NSRP #0349
May 1992

P-52 Balloting of Hull
and
Mechanical Standards

Panel SP-6

FIGURE 1
TYPE I LADDER ELEVATION

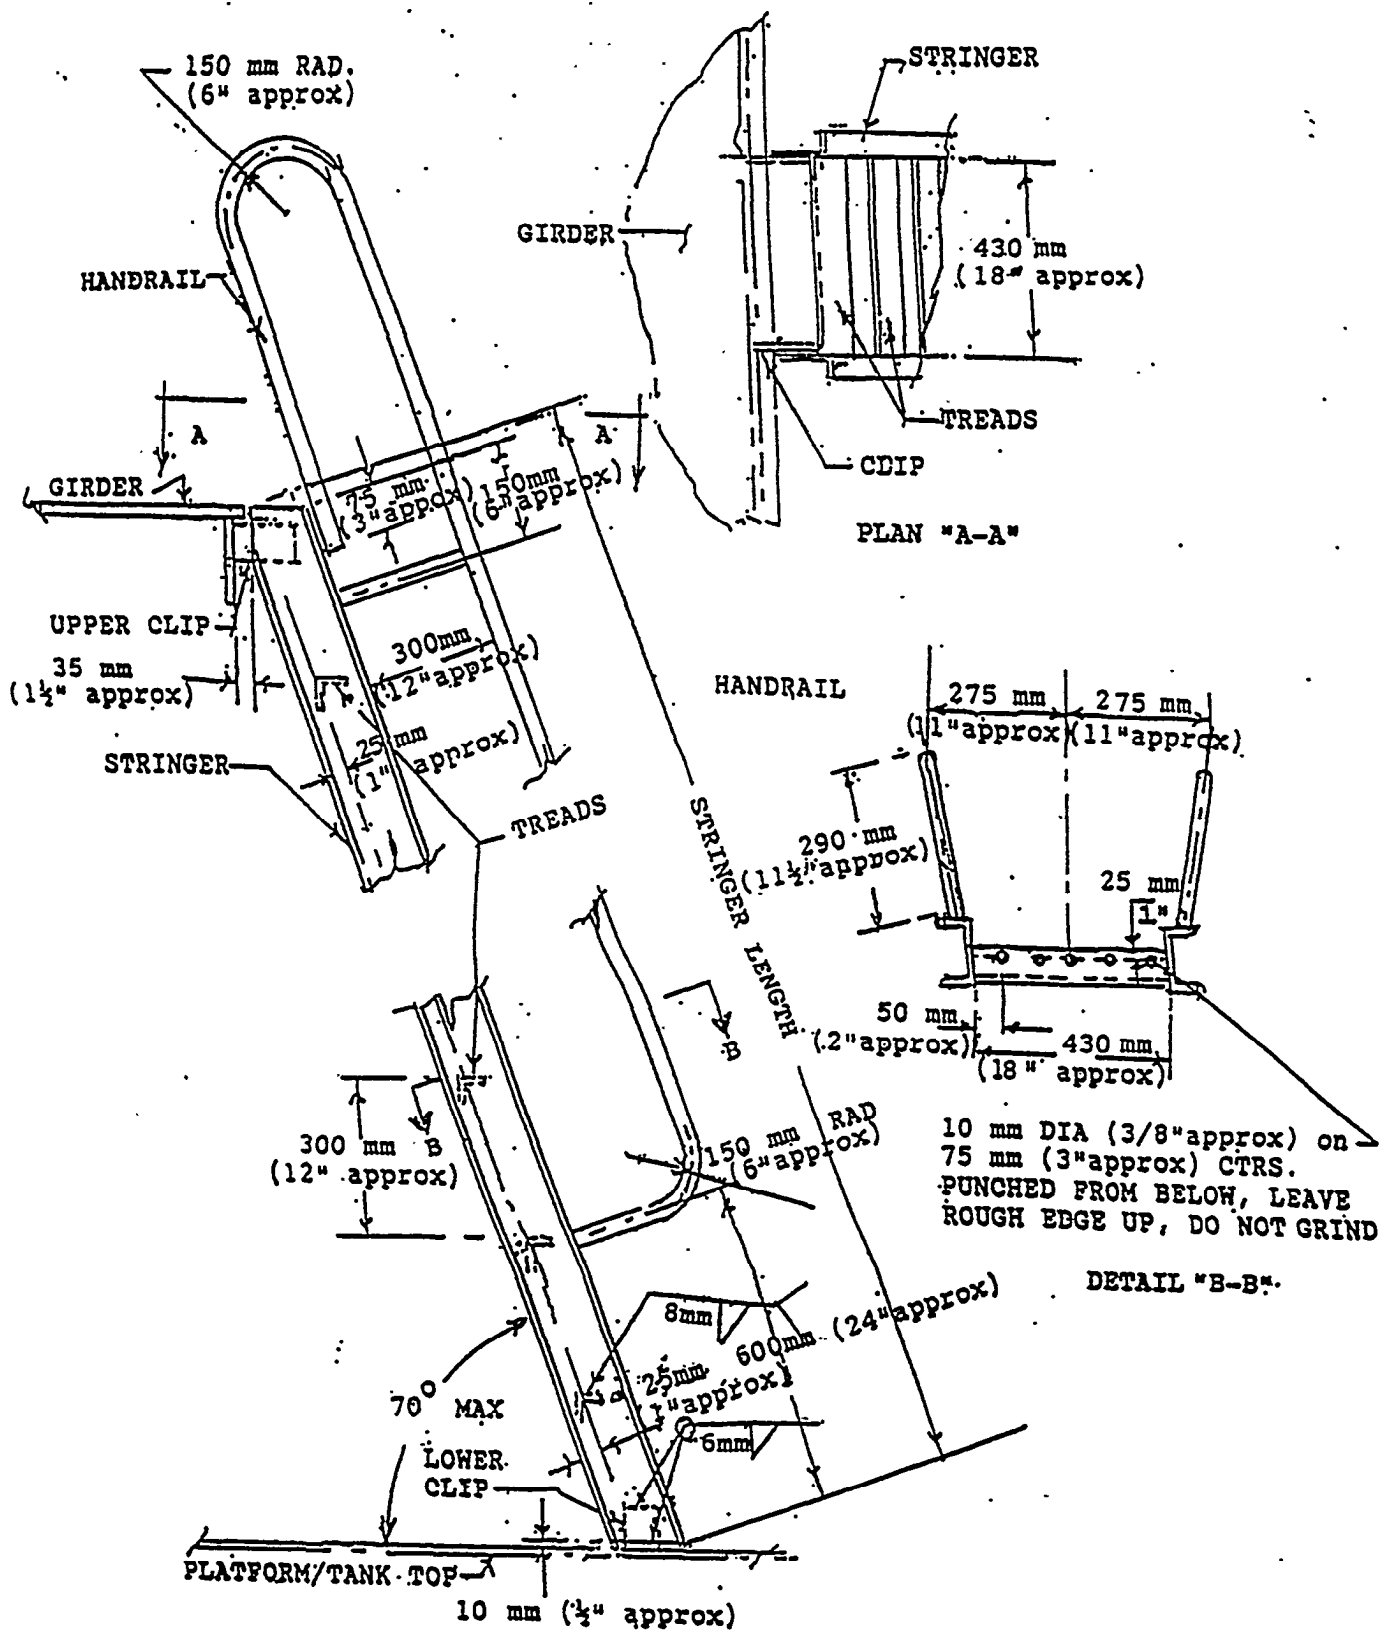
6. Fig.1 & Para 6 - Why is the tread width shown in detail A-A different from that in Detail B-8 & Para 6?

Concur - Revised, see A-A & B-B of Fig.1.
